গণপ্রজাতন্ত্রী বাংলাদেশ সরকার
শ্রম ও কর্মসংস্থান মন্ত্রণালয়
কলকারখানা ও প্রতিষ্ঠান পরিদর্শন অধিদপ্তর

ক্যাপ পর্যবেক্ষণের তথ্য

কারখানার নাম	শোনন সোয়েটারস লিঃ
ঠিকানা	Plot-A-118. S-36, BSCIC, Konabari, Gazipur
কারখানার কোড	GZP309
কালার কোড	
মূল্যায়নের ধরণ: কঠামোগত মূল্যায়ন	পর্যবেক্ষণের তারিখ: ১২-০৪-২০২৩
১. পর্যবেক্ষণ

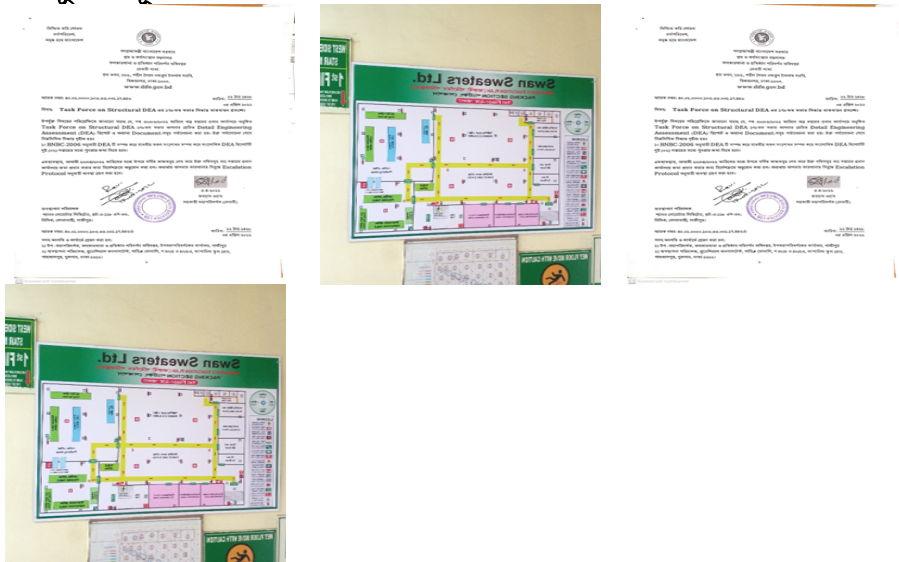
কার্যক্রম	Verify in-situ concrete stresses either by 100mm dia. cores or existing cylinder strength data for identified B6 columns.
সুপারিশের তথ্যসূত্র	
কারখানার কার্যক্রম	
অগ্রাধিকার	প্রযোজ্য নয়
চূড়ান্ত সময়সীমা	-
সংশোধিত সময়সীমা	০১-০১-১৯৭০
অগ্রগতির অবস্থা	সংশোধিত
মন্তব্য	09-April-2019: Core test results have been found on site with different name of the factory. No evidence of core cutting have been observed on site. 07-Nov-2019: Core test results have been found on site with different name of the factory. No evidence of core cutting has been observed on site. 04-Mar-2020: Core test report was found but factory name mentioned in core test report is not matched. Also, evidence of core cutting was not possible to verify due to plastering work. 19.10.2020: DEA report was submitted to DIFE for approval which covers the core test report. But the core test report states different factory name and no core cutting evidence was seen during inspection. 06-01-2021: Core test results have been found on site with different name of the factory. No evidence of core cutting have been observed on site. 10.08.2021: Core test results have been found on site with different name of the factory. No evidence of core cutting have been observed on site. 17.08.2022: Core test results have been found on site with different name of the factory. factory management says that, when the DEA work start & Core has been taken of the building then the factory name is Mega Fashion Wear Ltd. DEA Completion, return for correction & resubmission continue after a long time. in the mean time factory name is change by Shanon Sweater Ltd. Again after a same day factory change name by Swan Sweater Ltd. Also we verify core layout plan. core layout plan are matched with provide core layout plan. 12.04.2023: Completed.
